Ellis Parker Security Fencing
And Waterproofing 2015

C.I.P PROJECT NUMBER: 420.176.108

This addendum, consisting of a total of 3 pages forms a part of the Contract Documents and modifies the original documents dated May 4, 2015.

ADDENDUM #1

COURTYARD AND STAIR DEMOLITION PLAN

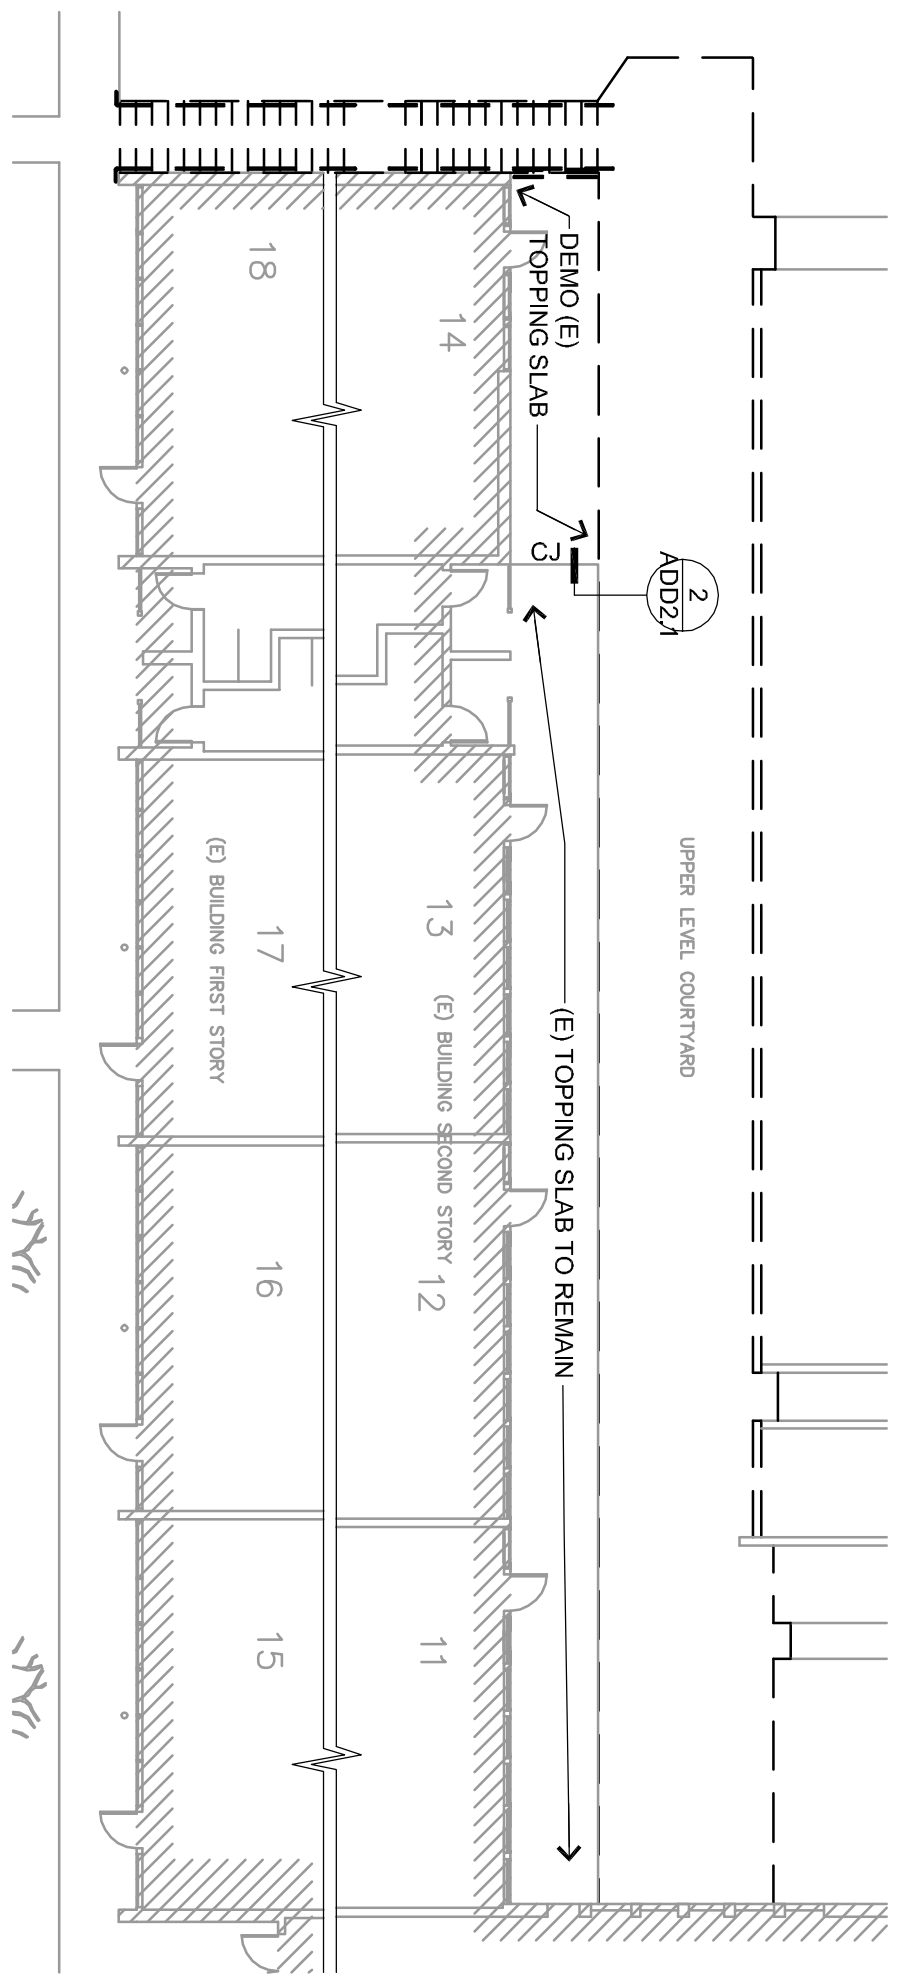
- 4) 1/A2.0 – (E) topping slab to remain south of (E) construction joint. See attached drawing ADD 2.1 for location and joint detail.
- 5) 2/A2.0 – Continue membrane waterproofing along intersecting southern courtyard wall 8 feet from
